**POWERCO**

**Consultation Paper: Proposed guideline for application of gas billing factors**

# Proposed guideline for application of gas billing factors

Figure 1: Example of daily pressure variation in a network

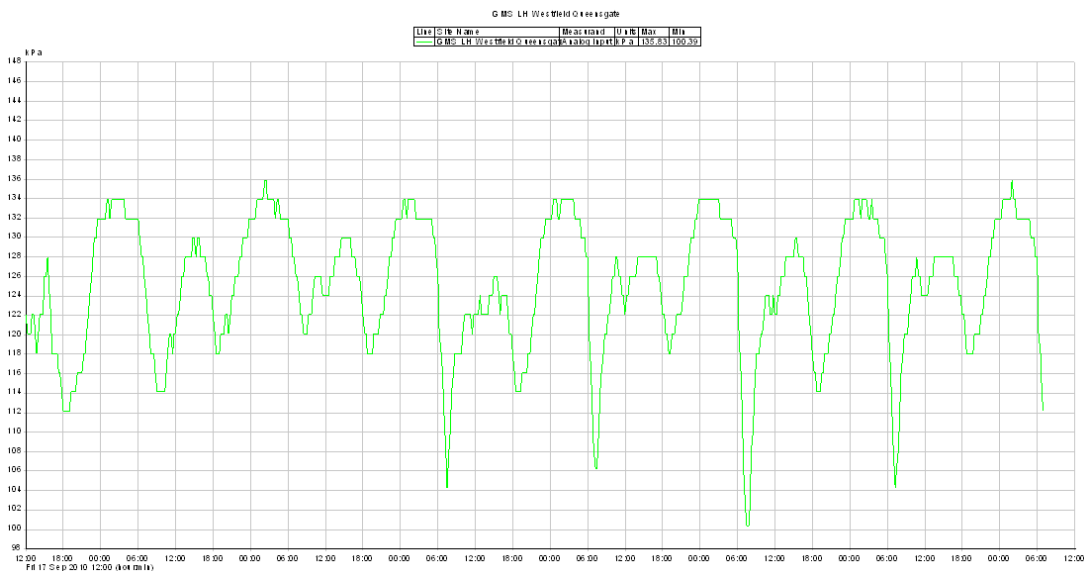
3. It is impossible for a Distributer to provide a meaningful figure for the network pressure in the Registry to allow the accurate calculation of the Joule-Thomson effect for each ICP in a network. At a macro level, nominal network operating pressures are not static but are managed dynamically i.e. District Regulating Station set pressures can be adjusted at any time for the purpose of managing network operations. In this case each time a distributor made a change they would have to find and adjust possibly hundreds of Registry records. More importantly the operating pressure of each network can vary over a range during normal operation, see *figure 1* below for an average example of pressure variation on a Powerco network with an operating pressure of 135 kPa; in this case the difference is 30%.

4. It is evident that during the periods of high demand, when there is maximum flow of gas through the GMSs, the actual network pressure will be at the lowest and therefore below any stated normal operating level in the Registry. Each sub-sector of the network will have its own unique operating range and profile that will vary with operational changes, and each ICP may have a profile different to the overall network (bakeries, swimming pools and other commercial and industrial sites are likely to exhibit such behaviour). So even if some average value could be derived, it could not be applied to ICP's without introducing significant inaccuracies.

Figure 2: Graph of 300 mm ground temperature audit post cooling temperature, and calculated upstream gas temperature.

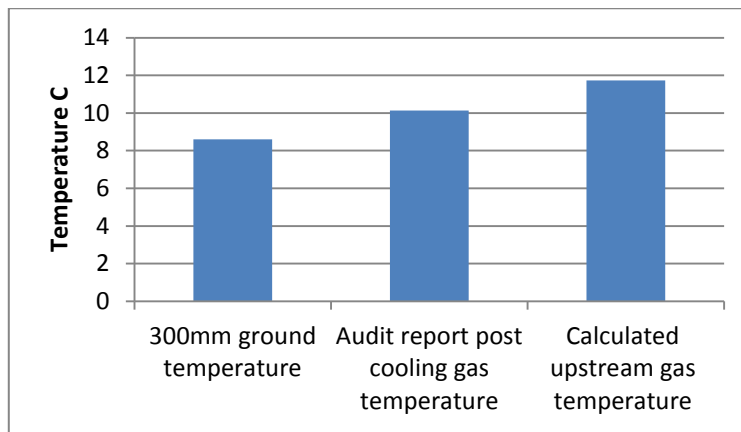
6. The Palmerston North Event Audit stated that ground temperature was 8.6°C (page 10), the average temperature of gas recorded in correctors at this time was 10.1°C (page 16), and the average temperature reduction due to the Joule-Thomson effect for a number of ICP's was determined by the author to be 1.6°C (page 11). The gas measured by the corrector had already been regulated, i.e. the expansion cooling had already lowered the temperature; therefore the approximate temperature of the gas in the network can be calculated to be  $10.1 + 1.6 = 11.7^{\circ}\text{C}$ . These temperatures are illustrated in the graph in *figure 2*.

- The network gas temperature is 36% different to the ground temperature that is recommended for reconciliation; this will have a material impact on the accuracy of energy calculations. The GIC's stated requirement that 300 mm ground temperature should be used as a proxy for gas temperature needs to be re-examined. As should any suggestion that a ground temperature database be established for use in reconciliation.
